ASSESSMENT REPORT

PEPPERTREE QUARRY
Site Layout and Infrastructure Modification
(06_0074 Mod 2)

Figure 3: Proposed Quarry Layout and Receiver Locations

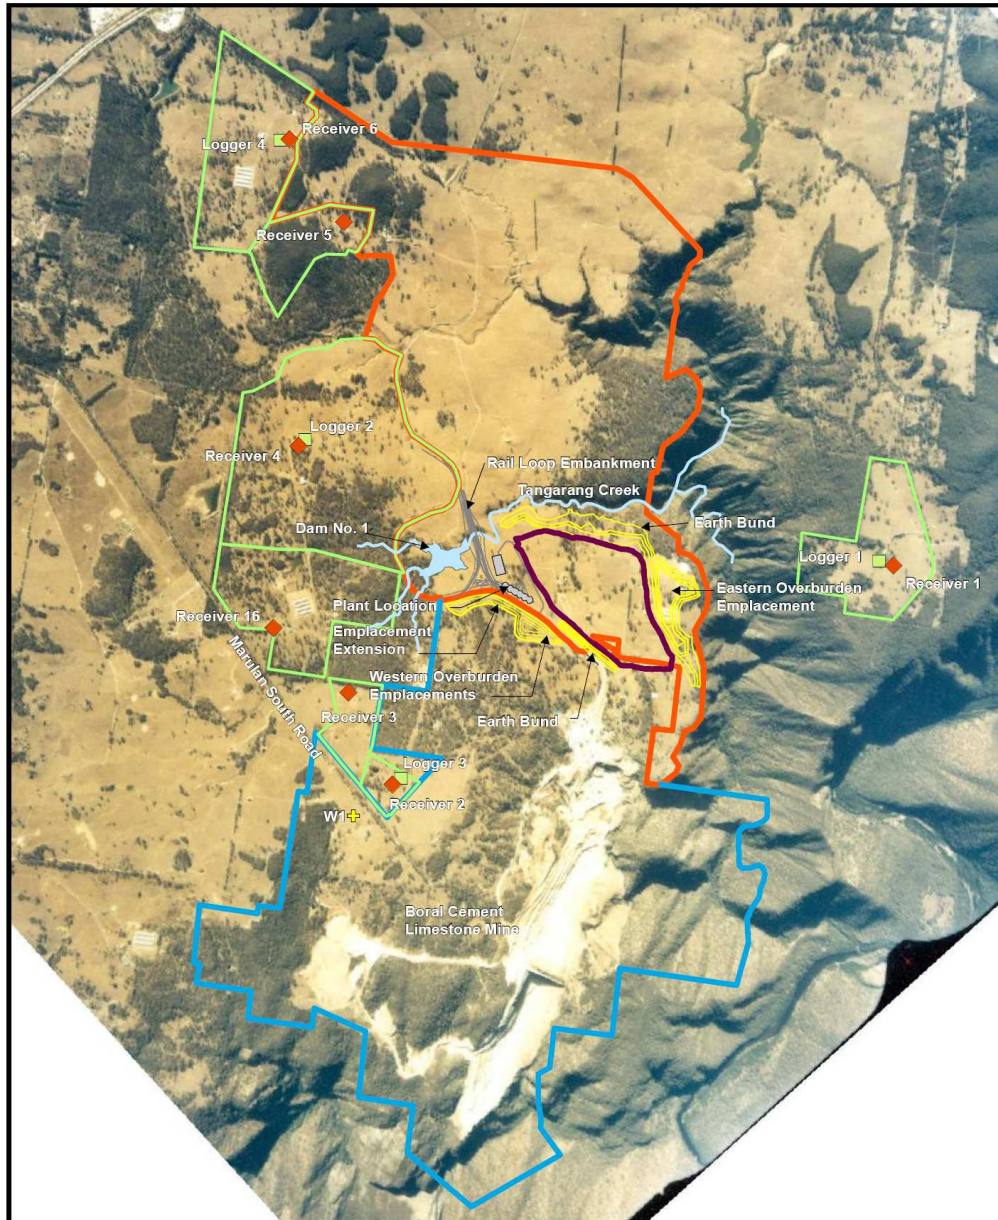
An additional residential dwelling (Receiver 16) has been constructed since the project approval, in close proximity to the quarry (see Figure 3). This receiver was not able to be considered in the original noise assessment and is therefore not currently subject to appropriate noise performance criteria under conditions 4 and 5 of the project approval. Boral has proposed to incorporate the new receiver into the project approval with a practical and achievable Project Specific Noise Limit (PSNL) derived in accordance with INP methodology and reflective of the ambient noise environment. Receiver 16 is in close proximity to Receiver 3 and is a similar distance from Marulan South Road which is considered to be the primary non-industrial contributor to existing background noise at these locations. Therefore the Relative Background Level (RBL) of 34 dB(A) $L_{A90(15 \text{ min})}$ and resulting PSNL of 39 dB(A) $L_{Aeq(15 \text{ min})}$ (ie RBL + 5 dB(A)) determined for Receiver 3 is considered to also be appropriate for Receiver 16.

The application of this derived daytime PSNL for Receiver 16 would result in an exceedance by the project of up to 2 dB(A). This exceedance is attributable to overburden operations in the proposed western emplacement and would only be experienced when northeast winds are approaching 3 metres per second. The existing operational noise impact assessment criteria in the project approval are based on either applying PSNLs or else the actual operational noise emission levels which could realistically be achieved. Boral has proposed a noise impact assessment criterion of 41 dB(A) $L_{Aeq(15 \text{ min})}$ at Receiver 16 for daytime operations. OEH supports this proposed noise limit and has recommended a noise limit of 35 dB(A) $L_{Aeq(15 \text{ min})}$ for night time operations, which is consistent with that for all other noise receivers. The

assessment also identified that the maximum operational noise levels at Receiver 3 would decrease by 2 dB(A) to 42 dB(A) $L_{Aeq(15 \text{ min})}$ for daytime operations, and it is proposed to reduce the relevant criterion in the project approval by a similar amount.

The Department has recommended that the proposed noise impact assessment criterion for Receiver 16 is incorporated into the project approval and the criterion for Receiver 3 is decreased for daytime operations to reflect predicted improved project environmental performance. Overall, the Department is satisfied that, with implementation of a comprehensive Noise Management Plan including noise monitoring and an active management system which includes an early warning alert system to identify and manage potential exceedances, the impacts of the modified project would be appropriately minimised, managed and monitored to ensure compliance with the noise limits. The Department has also recommended that conditions concerned with land acquisition and independent review of impact assessment criteria exceedance be updated, to reflect current standard conditions.
